October 30, 2006

Reference Site Plan Special Permit Application
Exchange Hall
Acton, Massachusetts
WDA JN 197.01

Response to Interdepartmental Communication, Engineering Department dated October 18, 2006:

SHEET 1 OF 1 SHEETS	NOLAN ENGINEERING CORP. 8 OLD BUCKLEY ROAD, MAYNARD MA 01954 DATE: APR. 13, 1988
	DESIGNED BY R. E. NOLAN	
	DRAFTED BY E. M. PLUTO	PLAN OF LAND ON MAIN ST. & SCHOOL ST. IN ACTON, MASS. EASEMENT PLAN
	SCALE 1"=40'	
	DRAWN

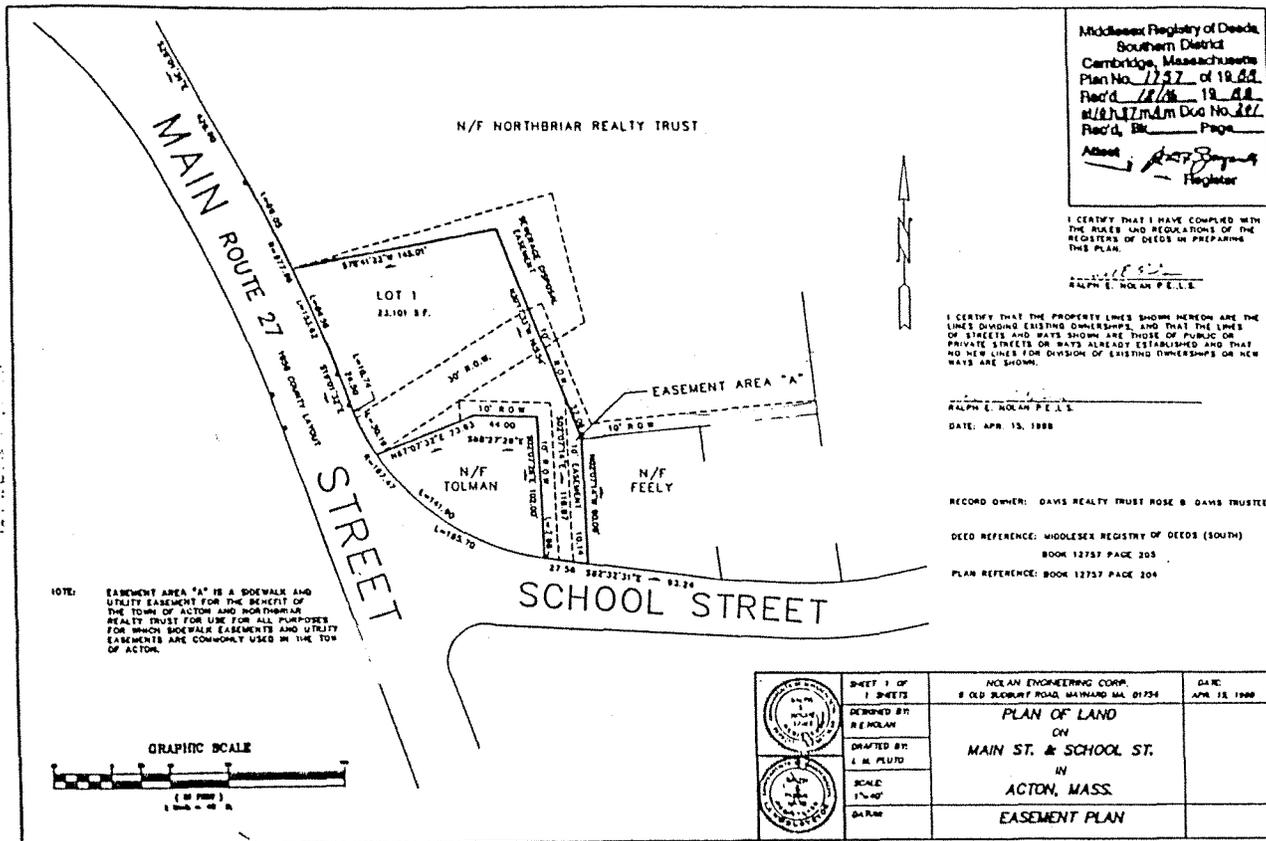
- 2) *The applicant needs to ensure the Town that they can legally install light poles, trees, etc. into the existing 10-foot wide right of way adjacent to 12 School Street.*

We have enclosed a copy of the recorded easement deed for the Board's reference. The deed declares the rights of grantee, however does not provide any restrictions to the allowed uses by the grantor. Typically, the grantor is allowed to improve the land contained within an easement provided that it does not prohibit the grantee from using the easement in a manner consistent with that described in the document. We submit that the improvements required as part of this proposal will not inhibit the allowed rights of the grantee from using the easement as intended.
